STAFF REPORT

RE: 255 Trumbo Road (Landscape Sec 108 Review)

FROM: Karen DeMaria, City of Key West Urban Forestry Manager

SHEET TITLE
DEMOLITION PLAN
SHEET NUMBER
L0.00

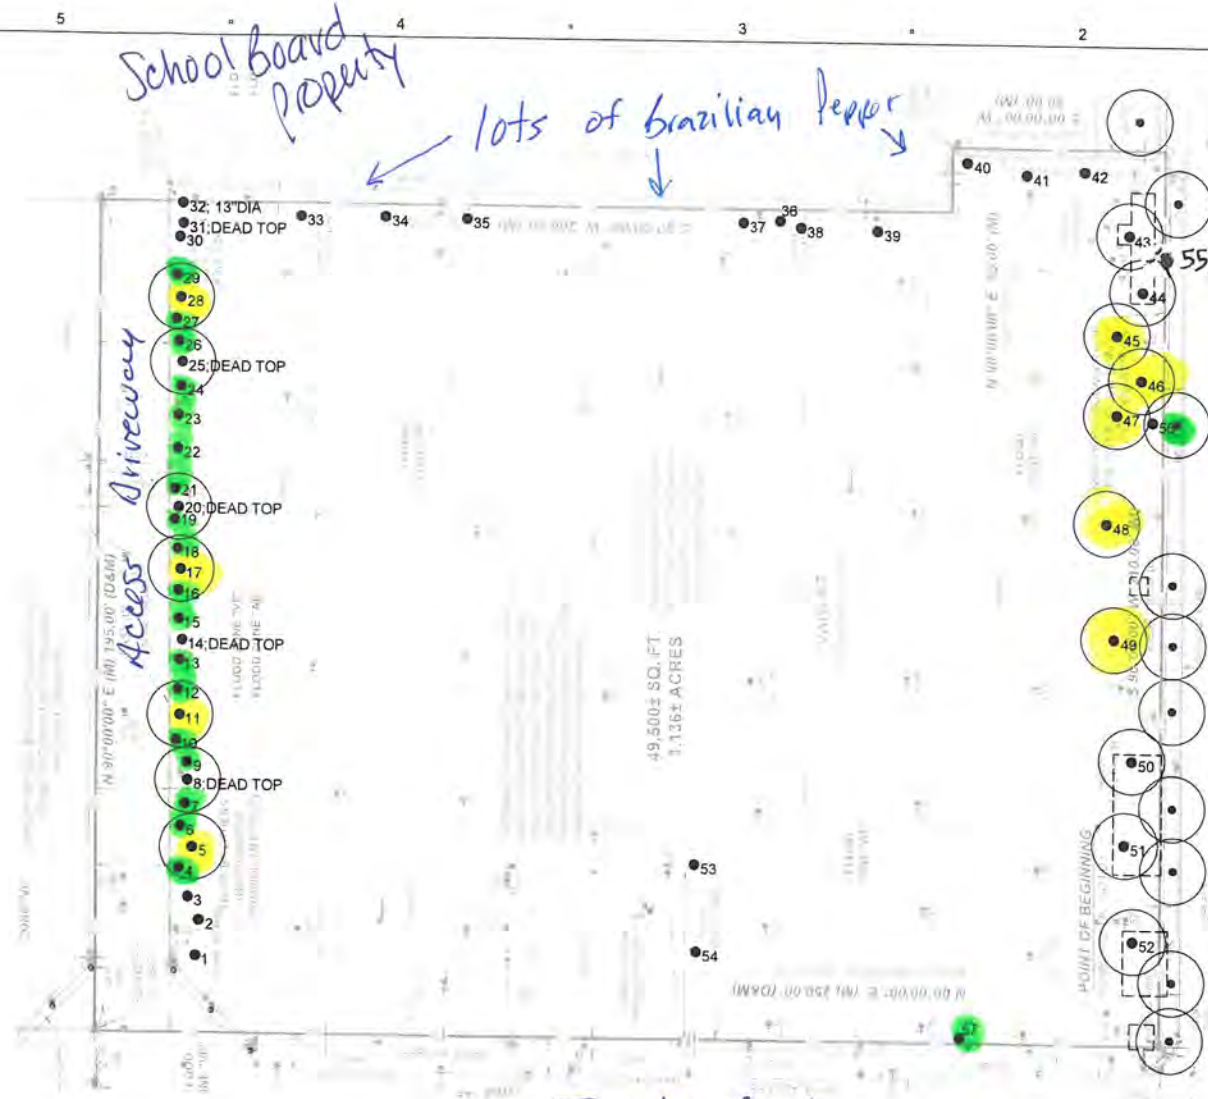
2. Sec 108-289: The Tree Commission reviewed the conceptual landscape plan with tree removal at their April 11, 2022 meeting. The project will require the removal of 18-Green Buttonwoods (tree #4, #6, #7, #9, #10, #12, #13, #15, #16, #18, #19, #21, #22, #23, #24, #26, #27, & #29), 1-young Fiddlewood (tree #56), and 1-young Gumbo Limbo (tree # #57), the transplantation of 9-Royal Palms (Palm #5, #11, #17, #28, #45, #46, #47, #48, & #49) on site, and the heavy maintenance trim of 2-Green Buttonwoods (Trees #53 & #54). Approximately 151.6 caliper inches of approved trees is required to be planted on the property to compensate for those trees removed. The landscape plan proposes to plant approximately 312 caliper inches of approved trees.

5. Sec 108-348 allows for credit of existing plant material. The Tree Commission reviews and approves the removal and transplanting of any regulated trees and palms from properties. At the April 11, 2022, Tree Commission meeting the applicant requested and received approval for the removal of protected trees and palms and received approval for the Conceptual Landscape Plan. The Conceptual Landscape Plan included the planting of all the required replacements on the property and the protection of (15) Green Buttonwood, (1) Fiddlewood, (6) Royal Palms, and (1) Sabal Palm to remain on the site and incorporated into the landscape plan. Credit has been given for these trees and palms during the review.

SHEET NUMBER
L3.00

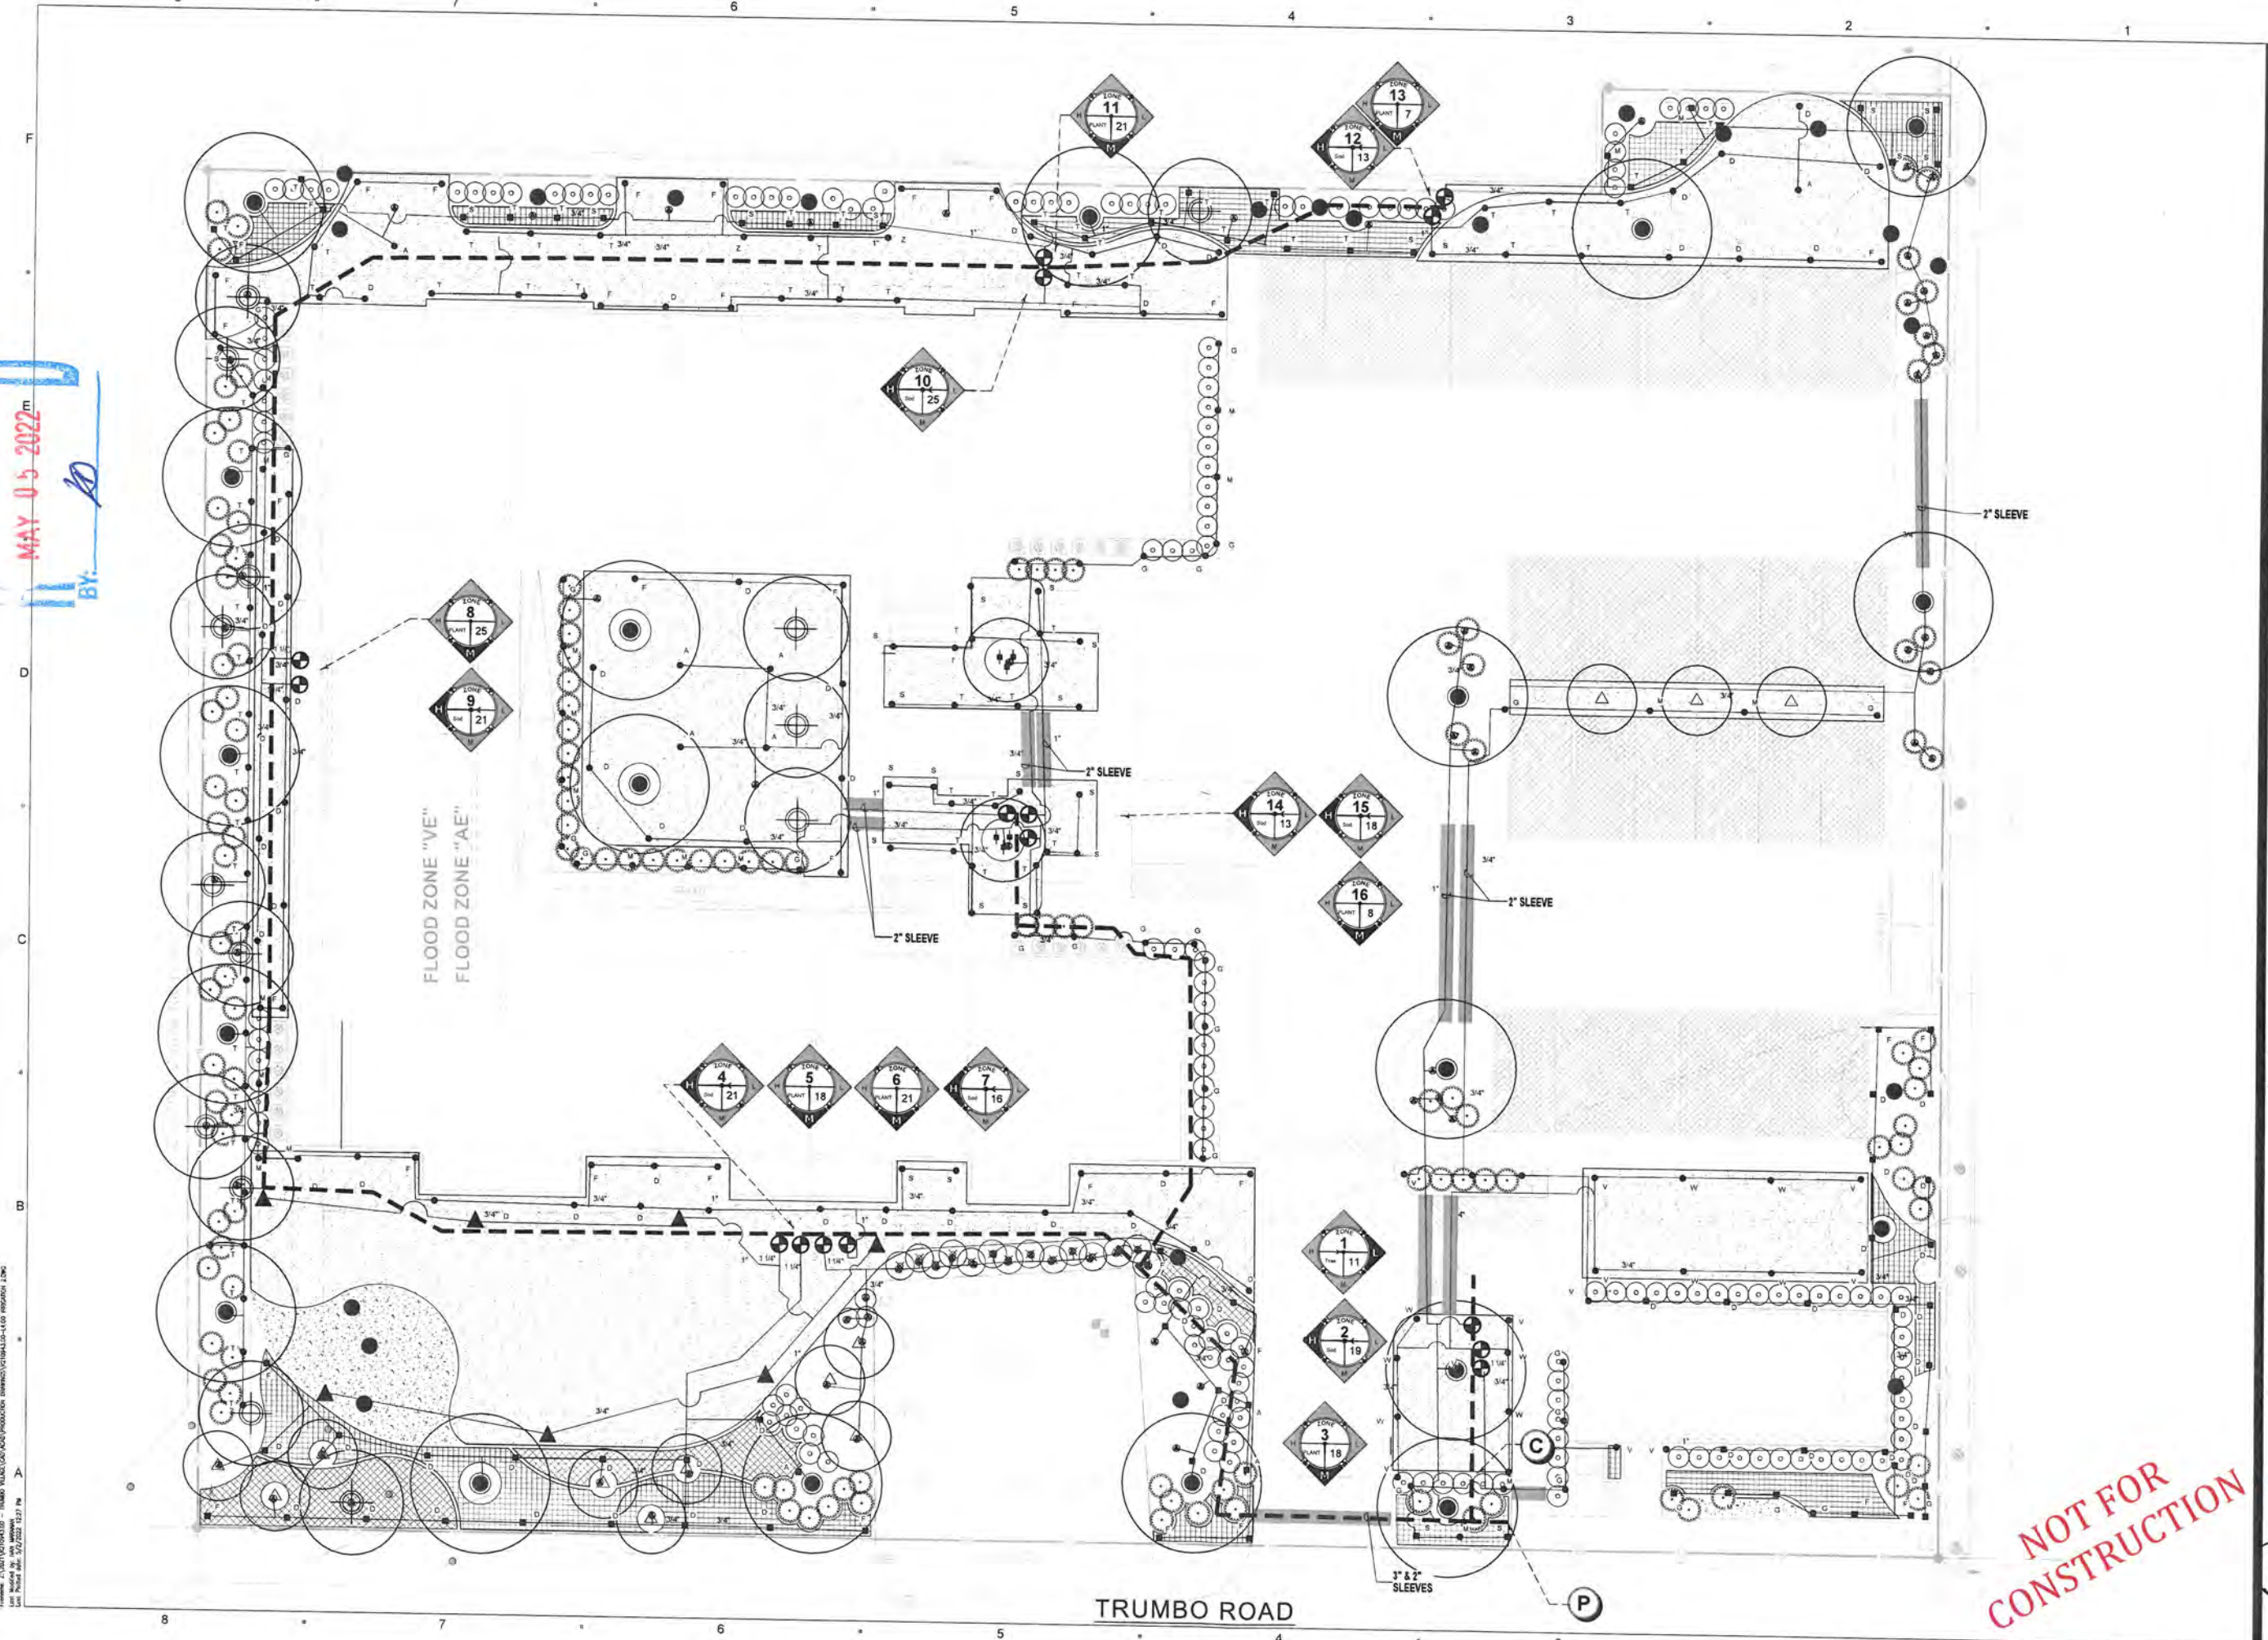
4. Sec 108-347 (bufferyards): The proposed use of the property is primarily multi-family residential. According to the property appraiser site, the adjoining properties on the north and east side (A&D on map) are listed as public schools land use and the property to the south (C on the map) is listed as condominiums.

According to the code, the buffer area labeled as "D" requires a total of 62.4 plant units. The proposed landscape plan includes the planting and transplanting of 9-Royal Palms and the planting of 4-Gumbo Limbo trees and numerous shrub species for a total of 136 plant units.

Buffer area "A" requires the planting of 100 plant units. The proposed landscape plan includes the protection and incorporation of 11 existing green buttonwood trees and 1-young sabal palm, the transplanting of 1-Royal Palm, and the planting of 4-Gumbo Limbo trees and some shrubs for a total of 204 plant units.

Buffer area "B" requires the planting of 41 plant units. The proposed landscape plan includes the protection of 4-Royal Palms and 1-young Fiddlewood tree and the planting of 1-Gumbo Limbo tree and some shrubs for a total of 57 plant units. This area abuts an existing landscaped area on the neighboring property.

Therefore, based on the information above, the landscape plan is in compliance with this section of code.

7. 108-413, landscape requirement along street frontages. The property is 1.14 acres therefore, this section of the code requires 120 plant units per 100 linear ft in a 30 ft wide landscape area for a total of 300 plant units needed. The landscape plan proposes to plant a total of 249 primary plant units to include (2) existing Buttonwood trees, 5-Gumbo Limbos, 9-Pigeon Plum trees, 2-existing Royal Palms, 83-tall shrubs (Silver Buttonwood, Wild Coffee, and coontie), and 305 assorted shrub beds to include cocoplum and cordgrass. The proposed landscape plan is in compliance with this section of code.

8. Sec 108-414 Interior parking areas: The interior parking area complies with this section of the code. Parking islands have at least one tree and sod for every 100 square feet and there is a landscape strip separating the head in parking areas. Plans do not show clearly curbing or parking stops in the parking area. This will need to be clarified or added as a condition.

10. Sec 108-447: The landscape plan does include a tree protection plan but it does not clearly show parking stops or curbing in the entire parking area.

1. All Brazilian pepper trees, an invasive exotic plant species, currently on the site will be removed. Due to the seed source being in the soil, the property maintenance plan must include a statement regarding continual maintenance of the property to remove any invasive exotic plant species including Brazilian Pepper (*Schinus terebinthifolia*), Lead tree (*Leucaena leucocephala*), and Australian Pine (*Casuarina equisetifolia*).
2. Plans need to show clearly curbing or parking stops being placed in the parking area to protect landscaped areas.
